<b>Title - Sujet</b> Building Envelope Rehabilitation	
<b>Solicitation No. - N° de l'invitation</b> F1700-174255/A	<b>Amendment No. - N° modif.</b> 005
<b>Client Reference No. - N° de référence du client</b> F1700-174255	<b>Date</b> 2017-10-18
<b>GETS Reference No. - N° de référence de SEAG</b> PW-SPWY-022-8185	
<b>File No. - N° de dossier</b> PWY-7-40209 (022)	<b>CCC No./N° CCC - FMS No./N° VME</b>
<b>Solicitation Closes - L'invitation prend fin</b> <b>at - à 02:00 PM</b> <b>on - le 2017-10-23</b>	<b>Time Zone</b> <b>Fuseau horaire</b> Pacific Daylight Saving Time PDT
<b>F.O.B. - F.A.B.</b> <b>Plant-Usine:</b> <input type="checkbox"/> <b>Destination:</b> <input checked="" type="checkbox"/> <b>Other-Autre:</b> <input type="checkbox"/>	
<b>Address Enquiries to: - Adresser toutes questions à:</b> Arthur (PWY), Carolyn	<b>Buyer Id - Id de l'acheteur</b> pwy022
<b>Telephone No. - N° de téléphone</b> (604) 364-2752 ( )	<b>FAX No. - N° de FAX</b> (604) 775-6633

**ADDENDUM 03**

1661 WHYTE AVE,  
VANCOUVER, BC  
**KITSILANO COAST GUARD STATION  
BUILDING ENVELOPE REHABILITATION**

**ADDENDUM 04**

Sheet/Feuille  
**ASK.002**

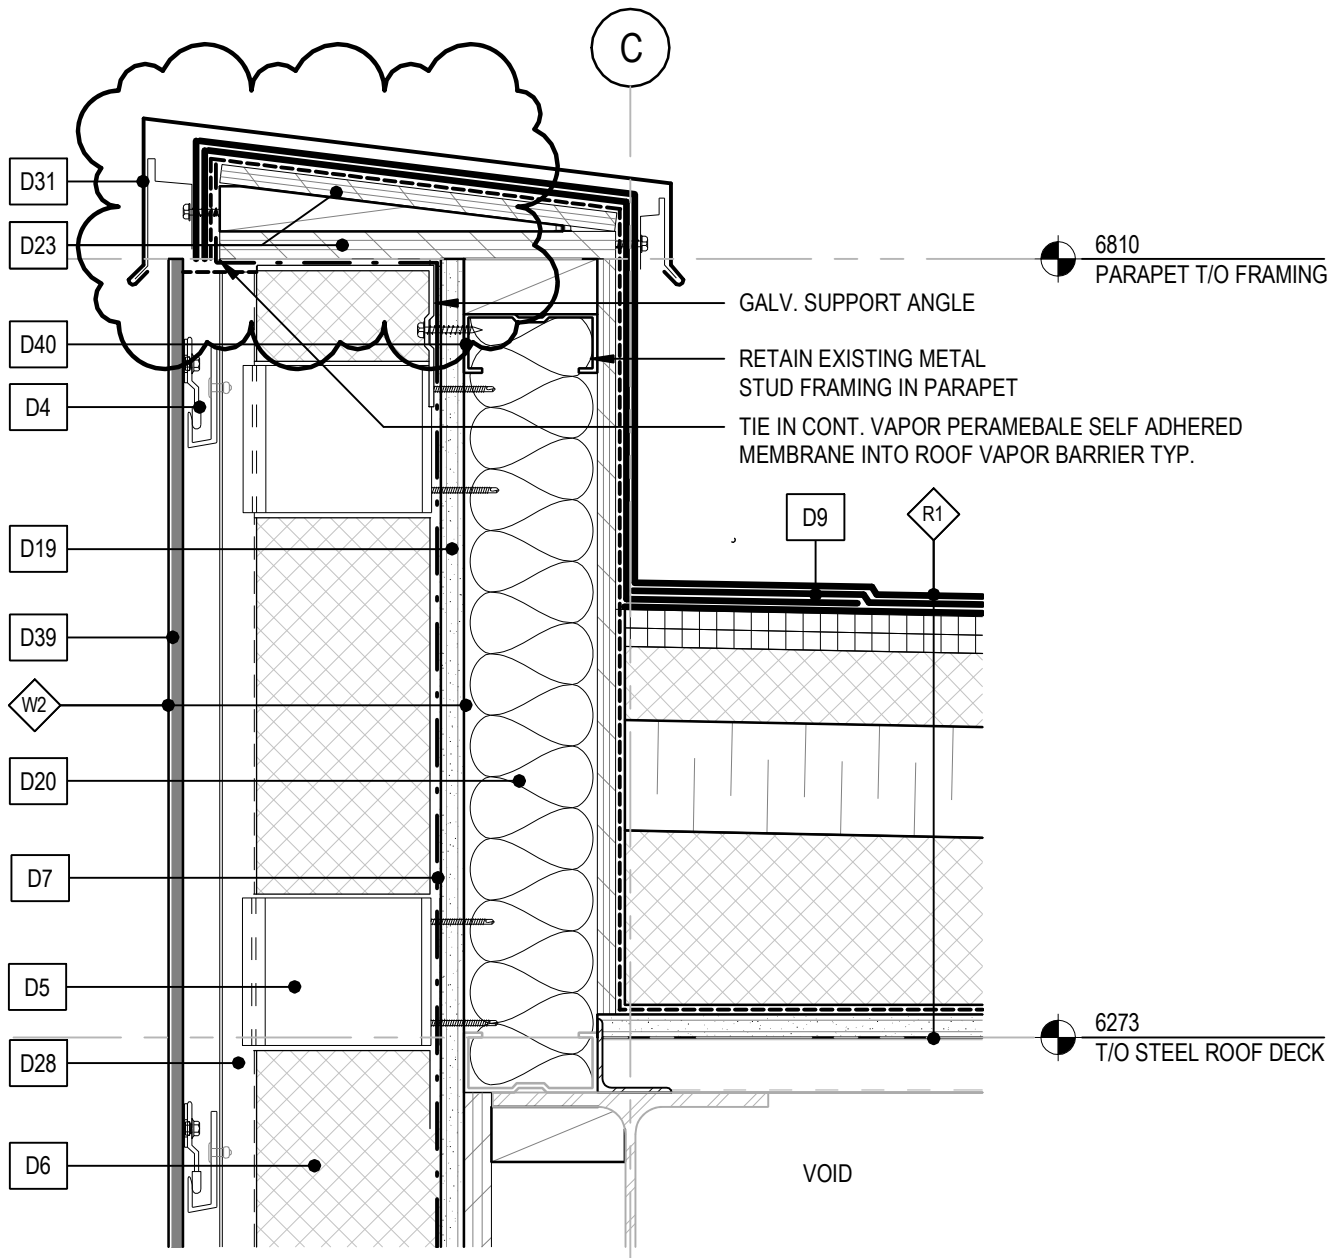
2. Detail 1 of A6.20- Typical Parapet  
Extend roof R1 membrane at parapet cap, so as to lap continuously with exterior wall W2 sheathing membrane, per ASK002, attached
